# Service Bulletin

ISSUE NO. M-045

**SUBJECT** MODIFICATION OF CRANKSHAFT

**APPLICABLE MODEL** GT750

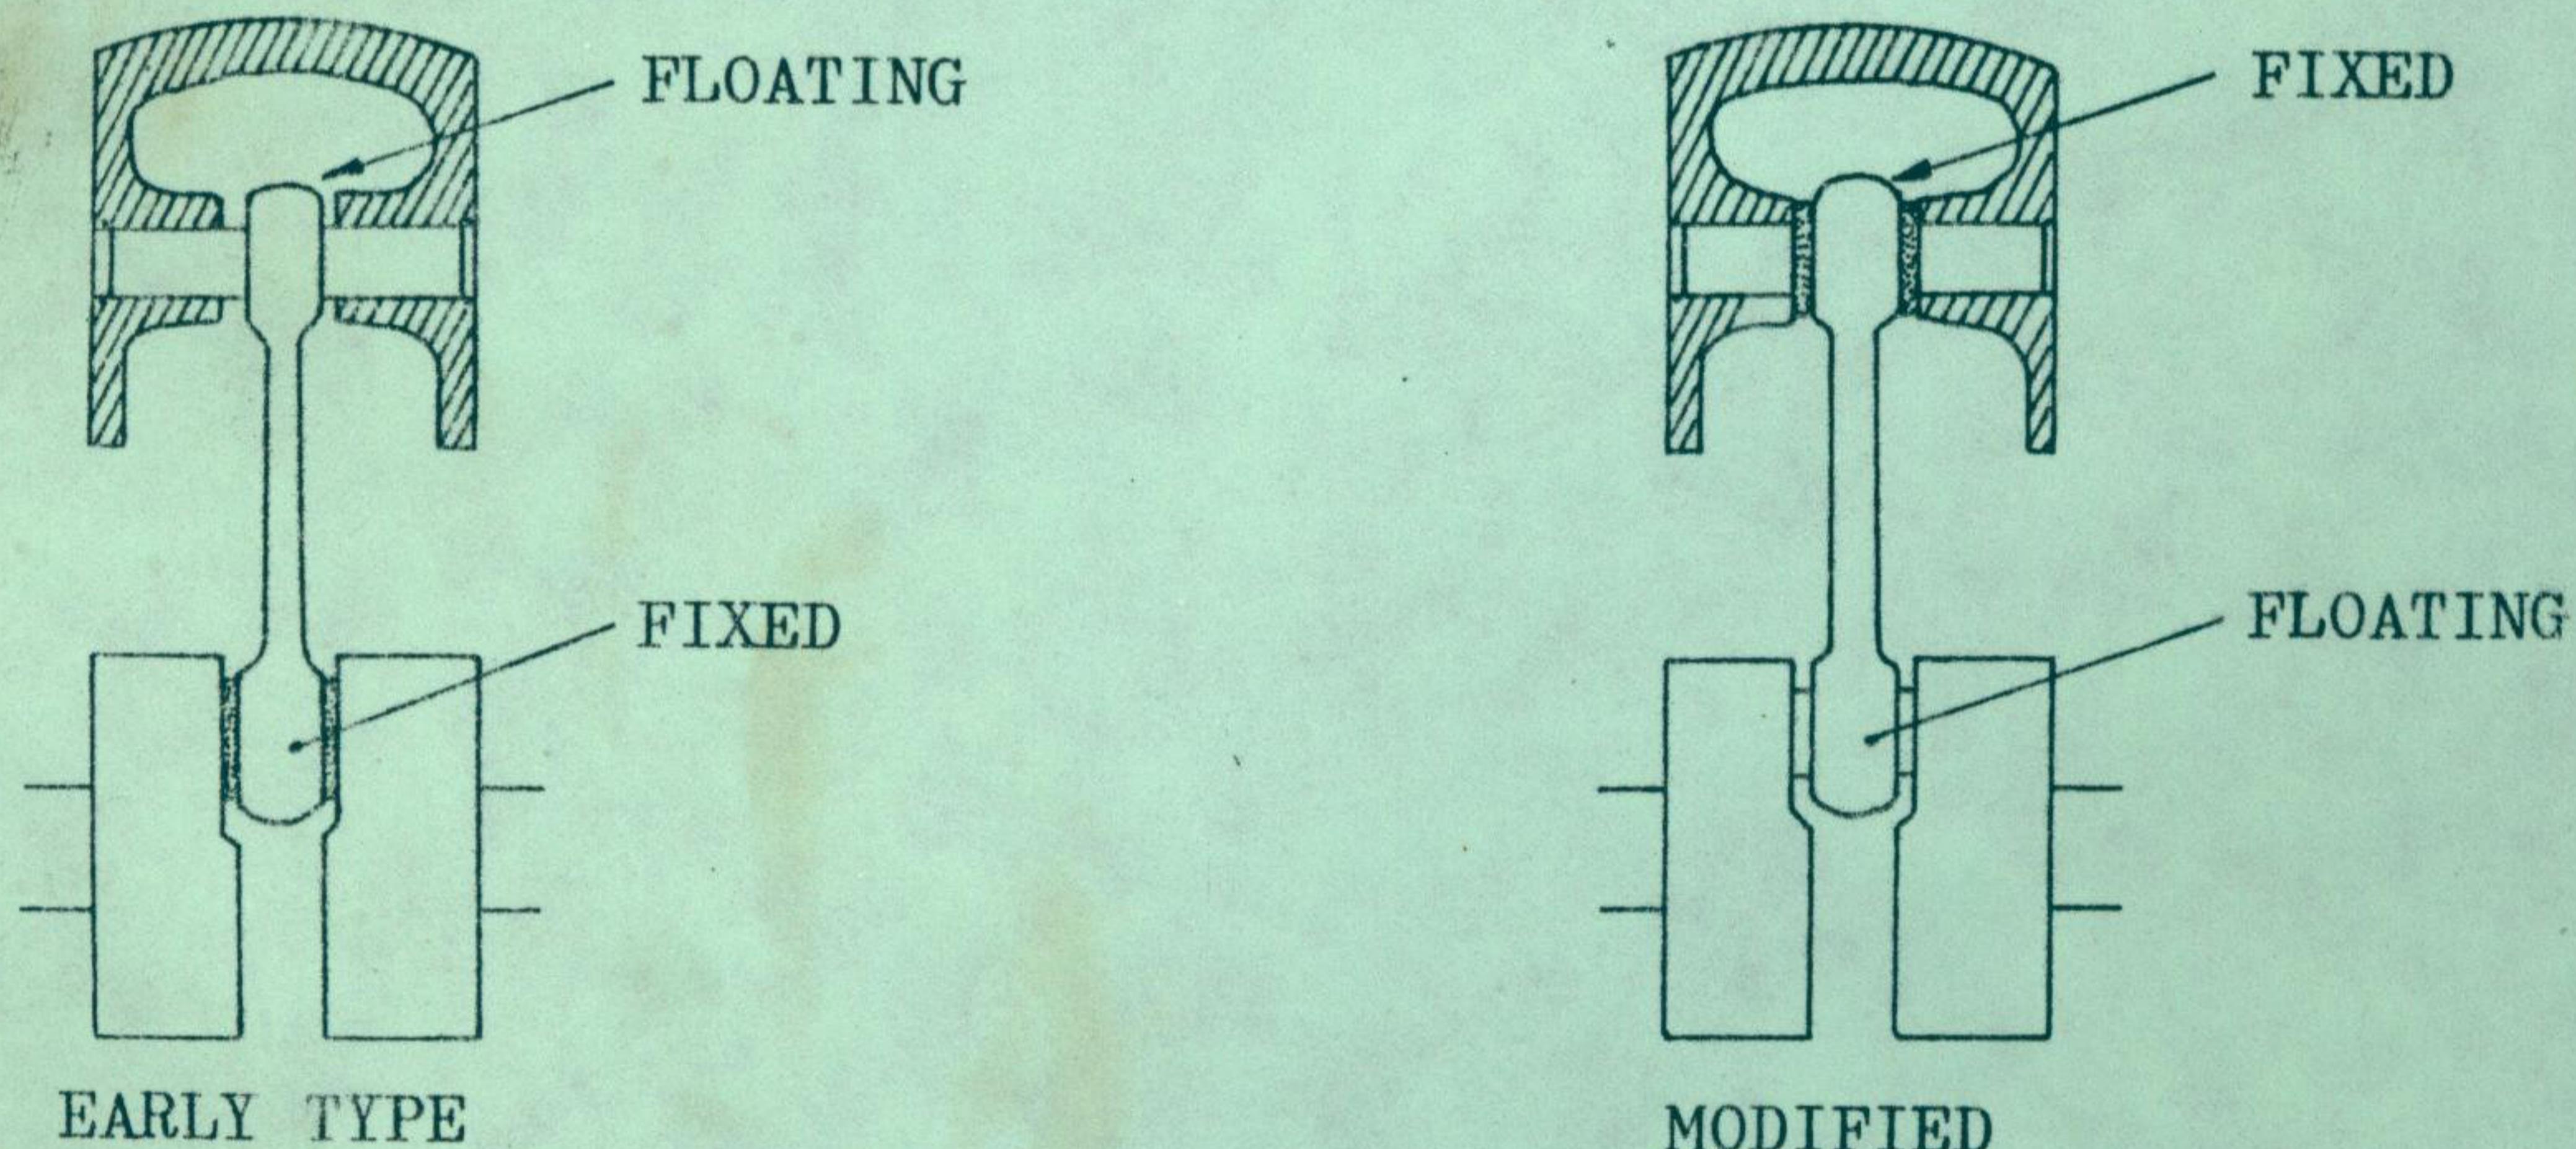
In the new type crankshaft of GT750, the movement of the con-rod in the direction perpendicular to the stroke is restricted by the limited space inside the piston and the big end support is a floating type unlike that in the conventional construction, the big end is fixed on the crank pin and the small end is floated. Above illustration shows these differences.

### 1) CON-ROD

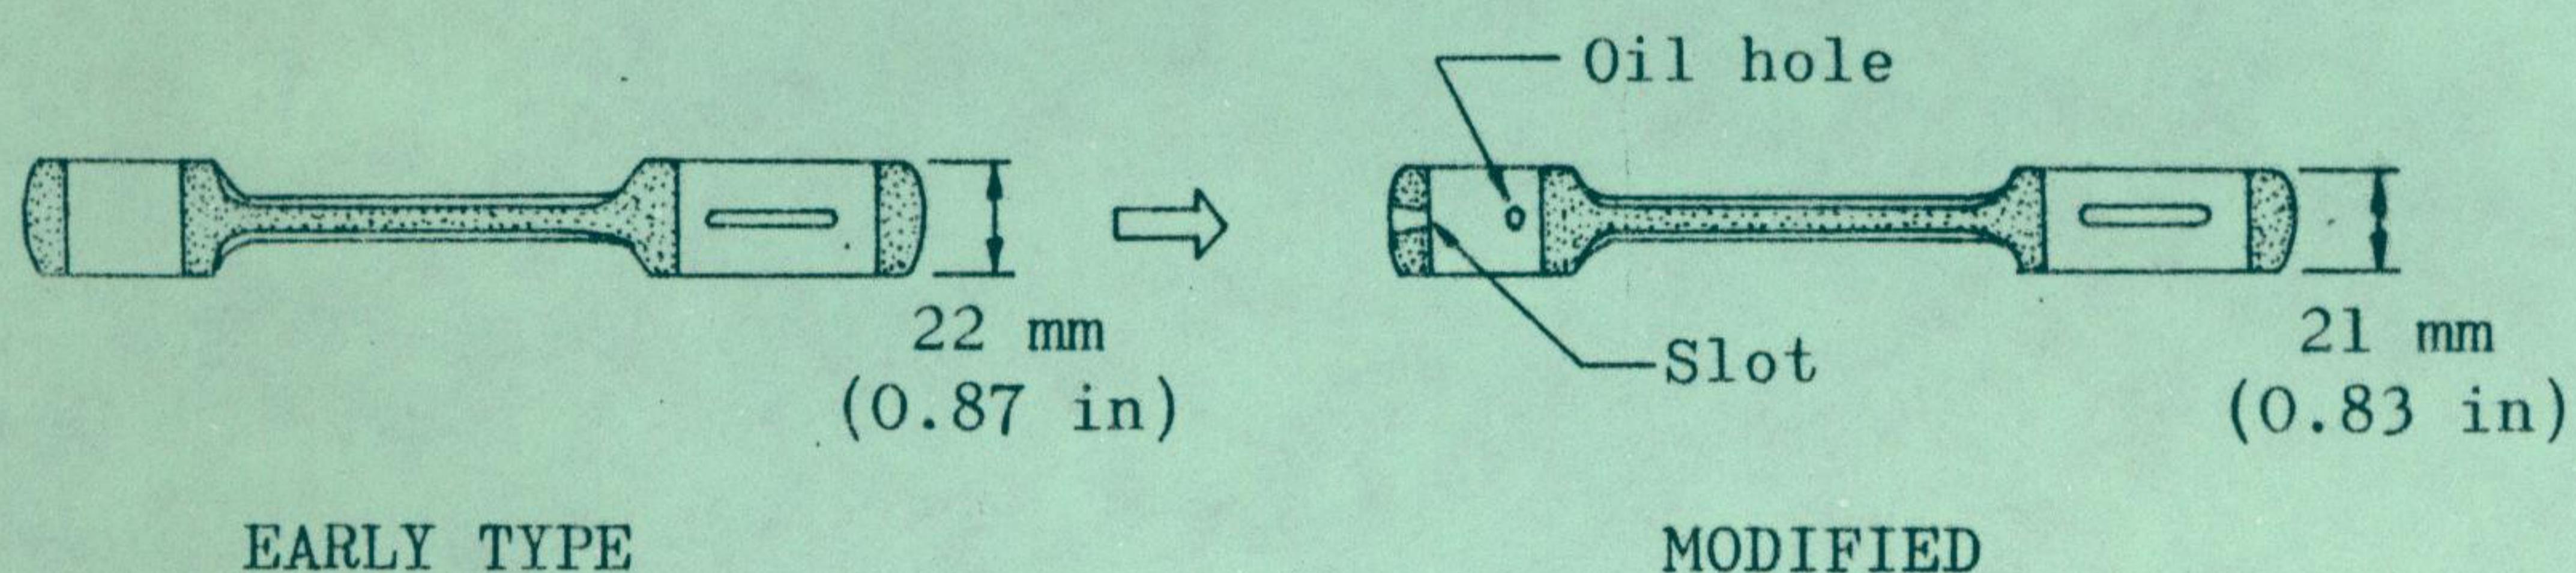
The width of the big end has been narrowed and a slot and a hole have been provided on the small end for better lubrication purpose.

### 2) CRANKSHAFT COMPONENTS

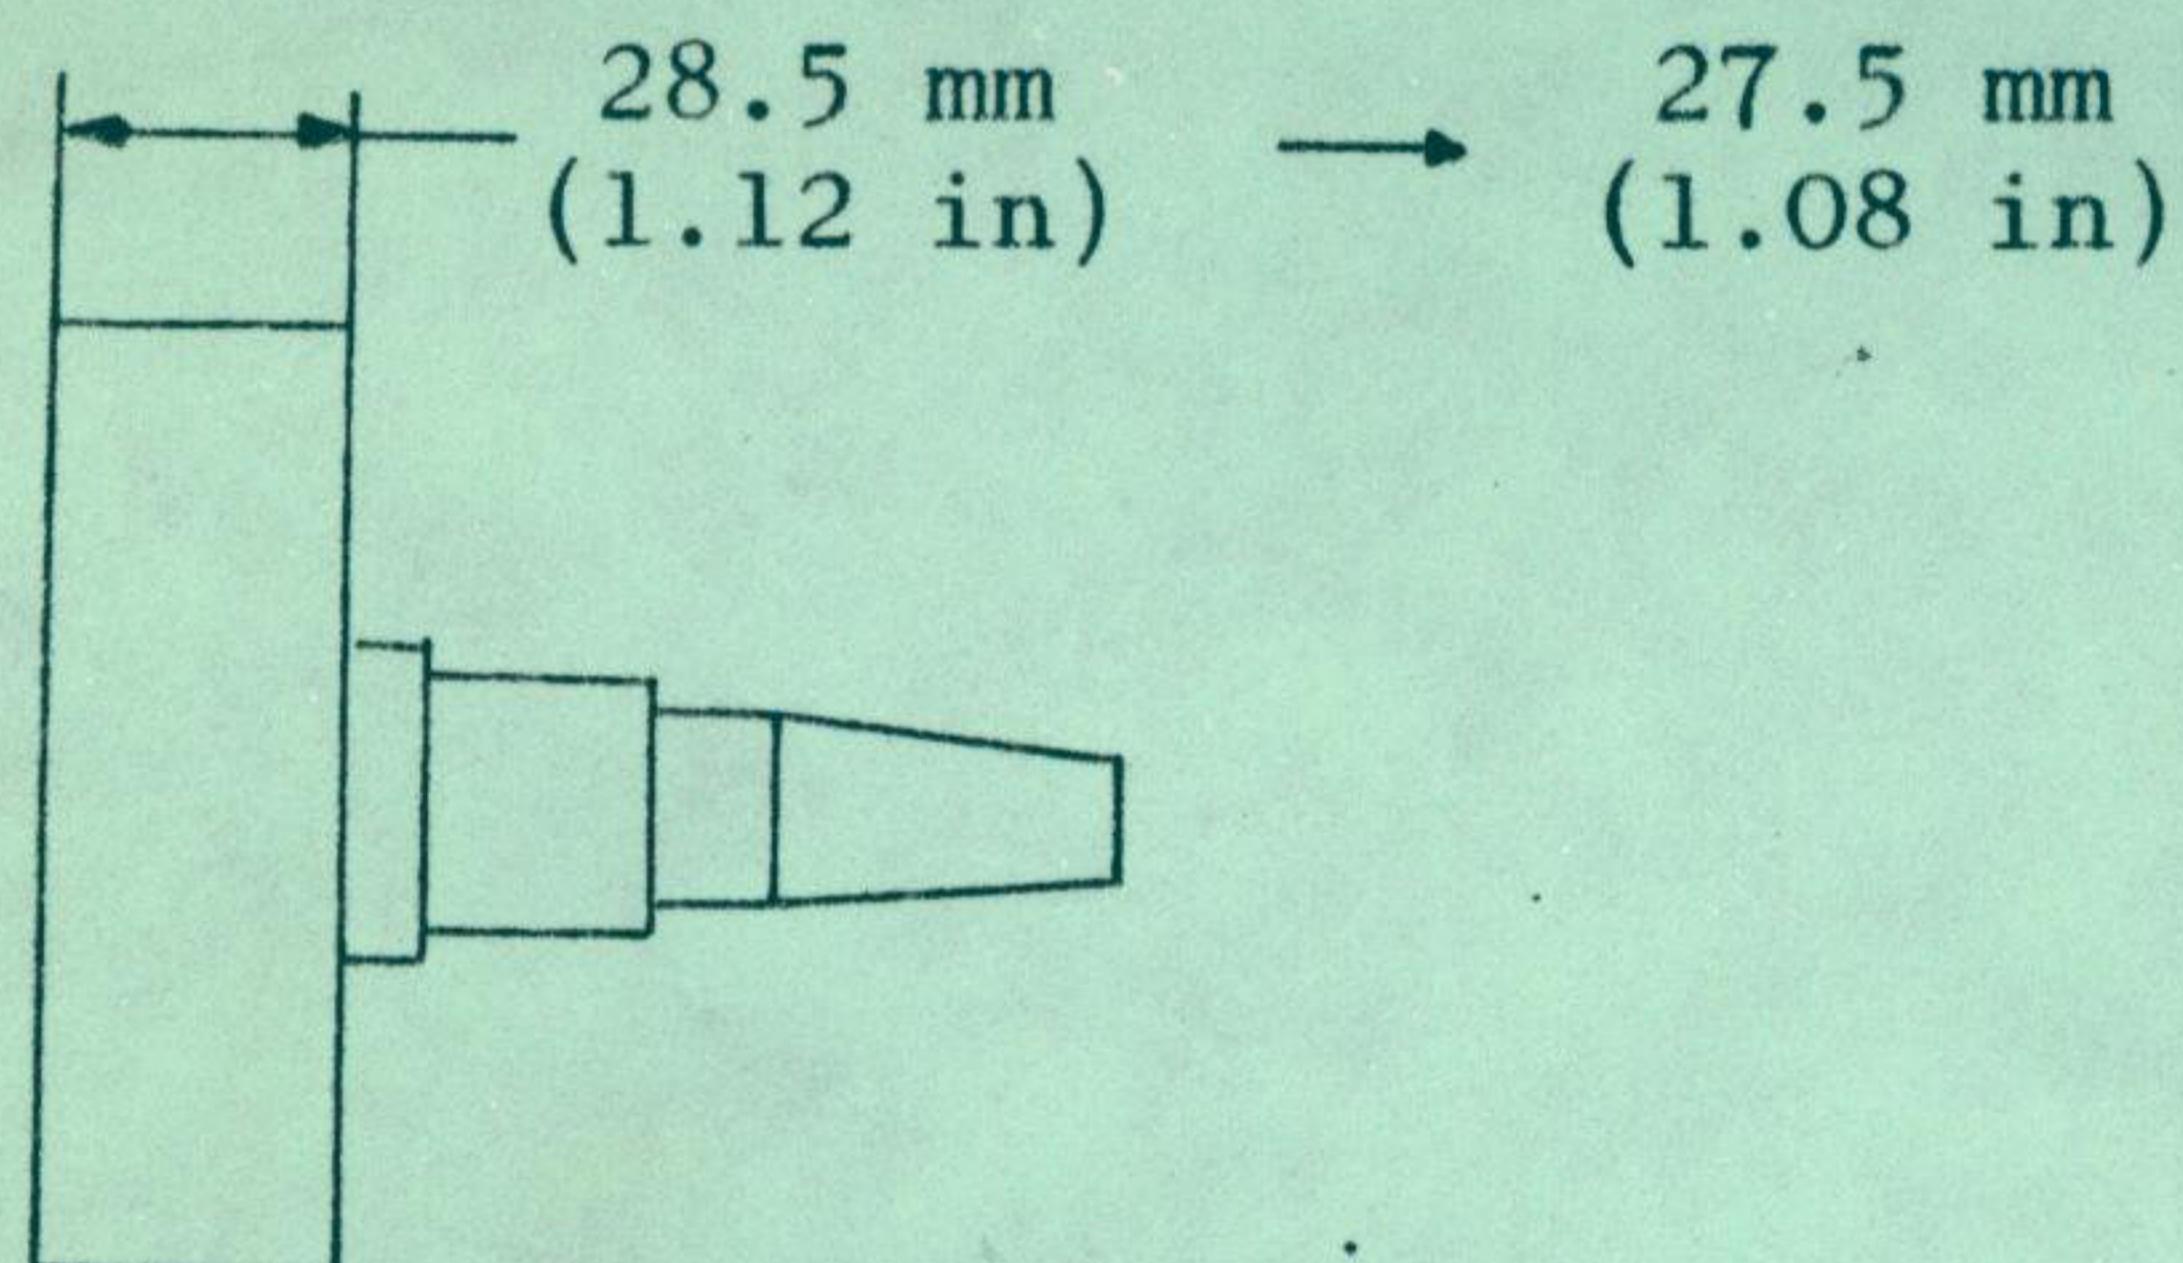
The width of the crank wheels has been narrowed from 28.5 (1.12) to 27.5 mm (1.08 in).

## PISTON

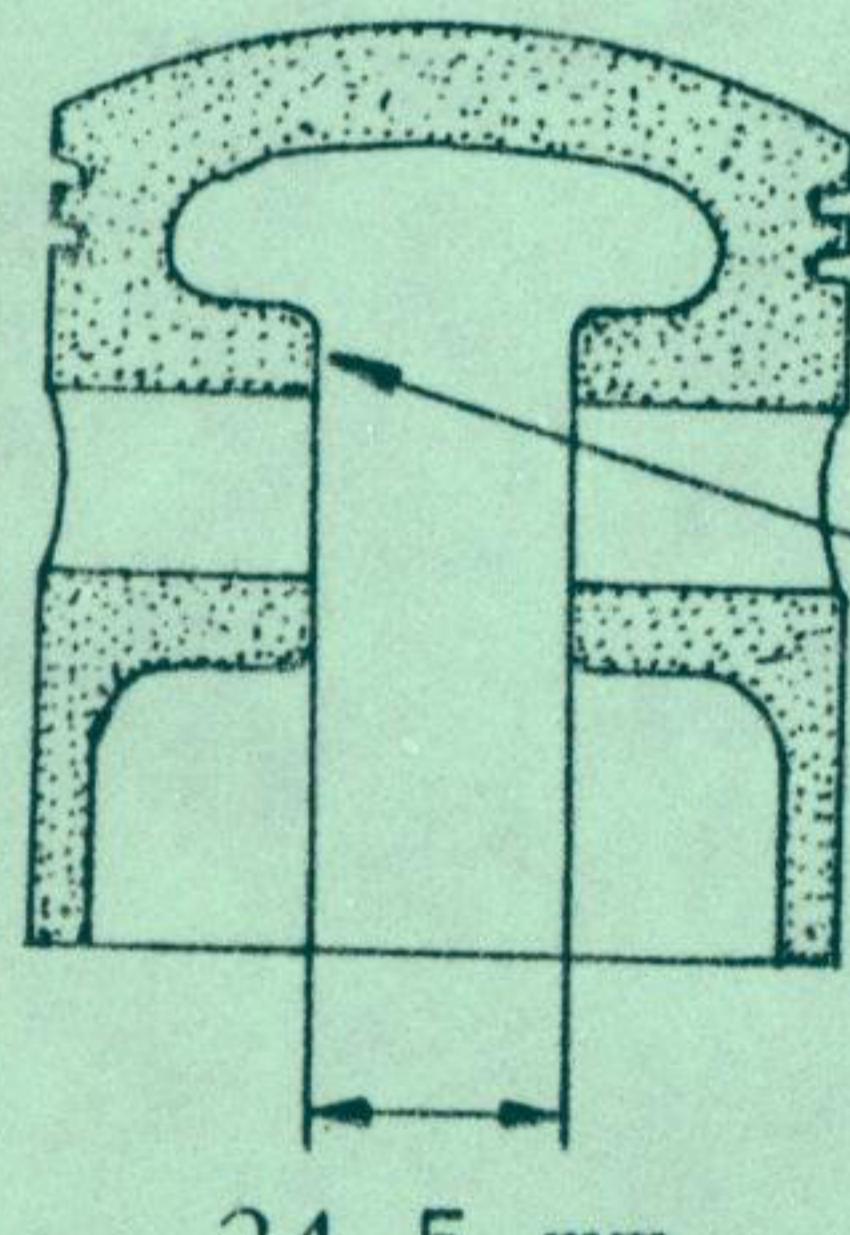
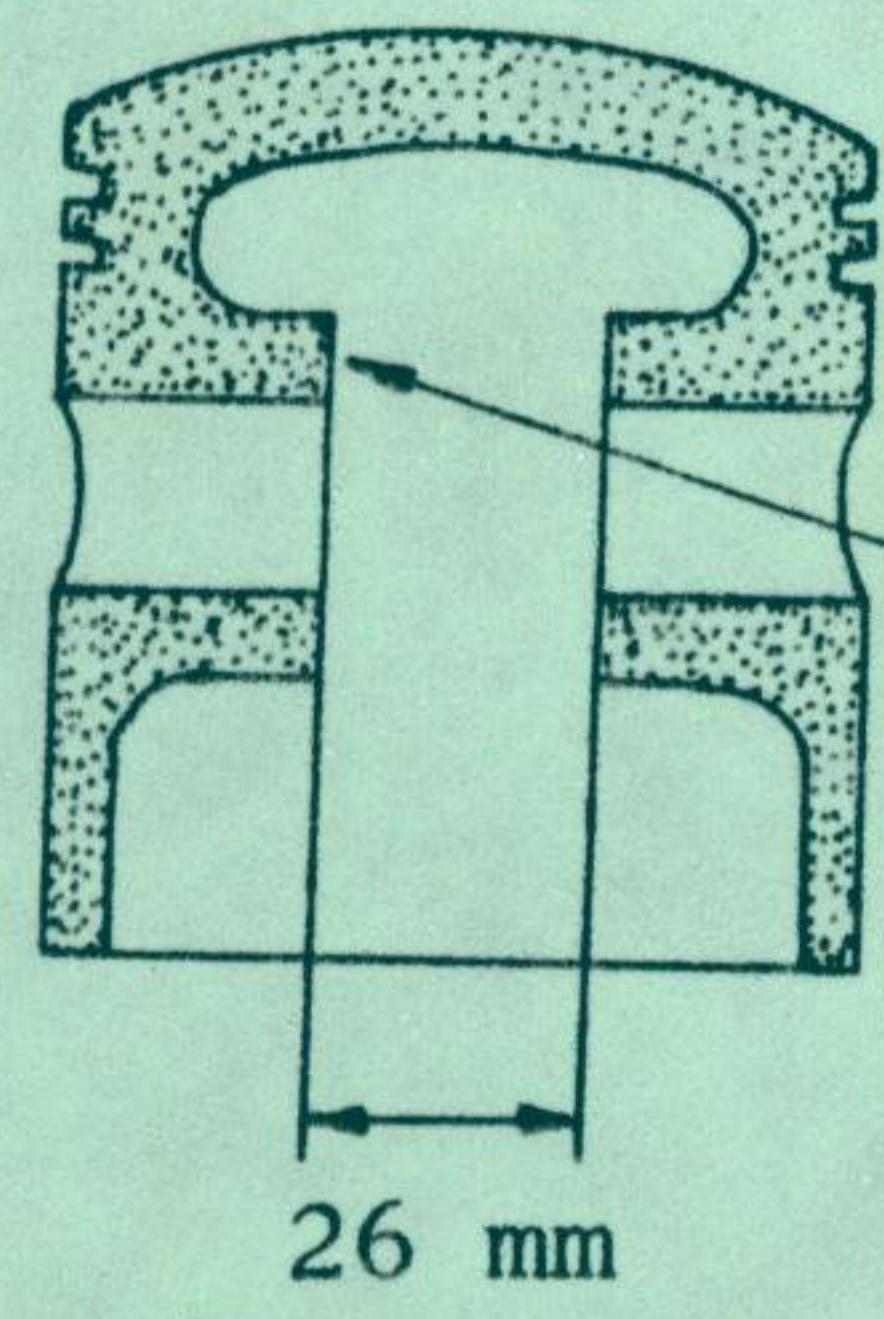
CASTING SURFACE

24.5 mm  
(0.96 in)

MACHINED

26 mm  
(1.02 in)

### THRUST WASHER, CON-ROD SMALL END

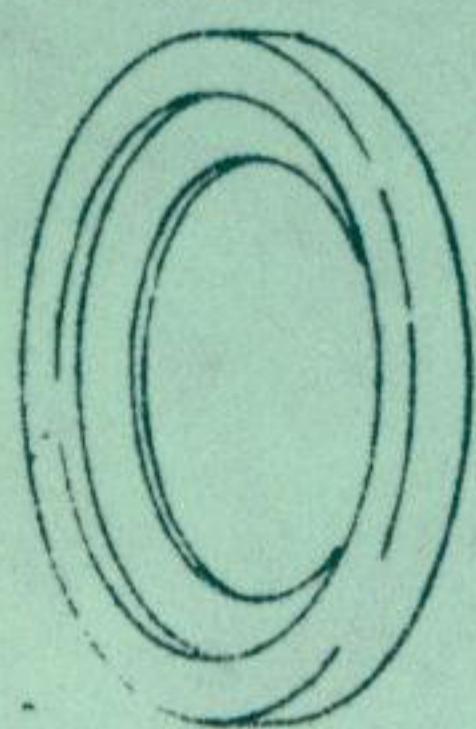
This washer has been newly provided for this modification and each two pieces of the washer are used per one piston.
